| 8802-3/802.3 REVISION REQUEST 1121 |

REQUESTED REVISION:
STANDARD: IEEE Std. 802.3-2002
CLAUSE NUMBER: 28C.6
CLAUSE TITLE: Message Code #5--Organizationally Unique Identifier (OUI) tag code

28C.6 Message code #5—Organizationally Unique Identifier (OUI) tag code

Figure 28C-1—Message code #5 sequence

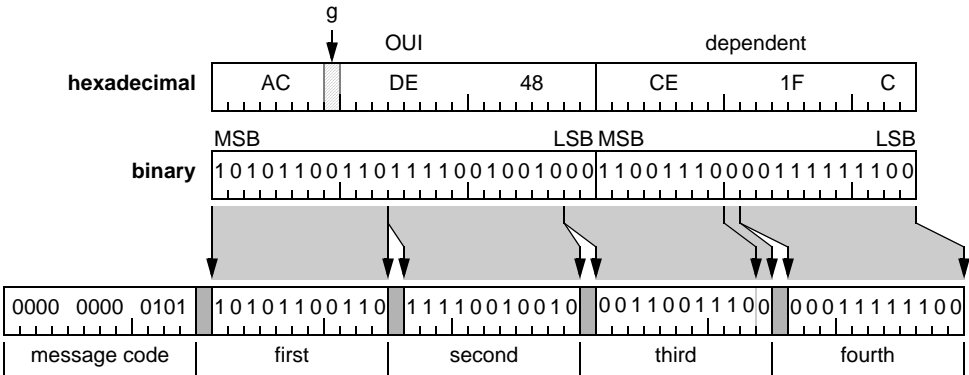
- 1) Bit-specification wording is very hard to follow; a figure is needed.
- 2) The bits within-byte ordering is unclear, given the conflicting meanings applied to "MSB" by the IEEE/RAC and following 28C.8.
- 3) The meaning of the remaining (not specified) bits is unclear.

- 1) Bit-specification wording is very hard to follow; a figure is needed.
- 2) The bit ordering within-byte ordering is unclear, given the conflicting meanings applied to "MSB" by the IEEE/RAC and following 28C.8.

Proposed solution (follows).
 Notes: If another bit ordering was intended, then change the figure accordingly.

The OUI Tagged Message shall consist of a single message code of 0000 0000 0101 followed by four user codes defined as follows. The first user code shall contain the most significant 11 bits of the OUI (bits 23:13) with the most significant bit in bit 10 of the user code. The second user code shall contain the next most significant 11 bits of the OUI (bits 12:2) with the most significant bit in bit 10 of the user code. The third user code shall contain the remaining least significant 2 bits of the OUI (bits 1:0) with the most significant bit in bit 10 of the user code. Bits 8:0 of the ~~third~~^{fourth} user contain a user-defined user code value that is specific to the OUI transmitted. The fourth and final user code shall contain a user-defined user code value that is specific to the OUI transmitted.

For example, assume that a manufacturer's IEEE-assigned OUI value is AC-DE-48 and the manufacturer-selected user-defined user code associated with the OUI is 1100 1110 0001 1111 1100₂. The message code values generated from these two numbers is encoded into four message codes, as specified in Figure 28C-1. For clarity, the position of the global broadcast g is illustrated.
